Document Number: D09809-A-A3560

4M Change Notice

Resin Molding SMD Type Ceramic Capacitors DK1 Series

Changes
HIC

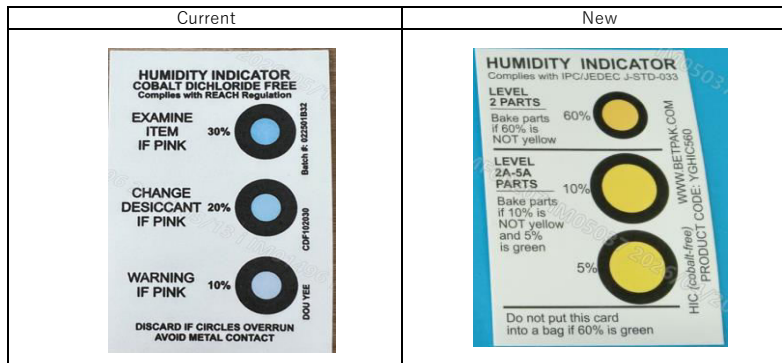
As shown in the photo above, we will be updating the HIC.
Due to the HIC update, some text and colors will change as shown above.

The color changes will be as follows:
Current: Blue ⇒ Pink
New: Yellow ⇒ Green

Label

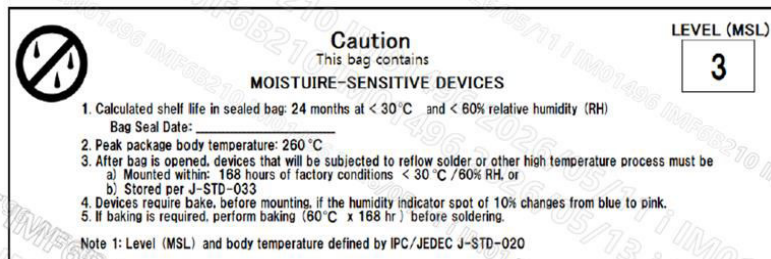
| Before Change | After Change |
|---------------------------|-----------------------|
| Current label information | New label information |
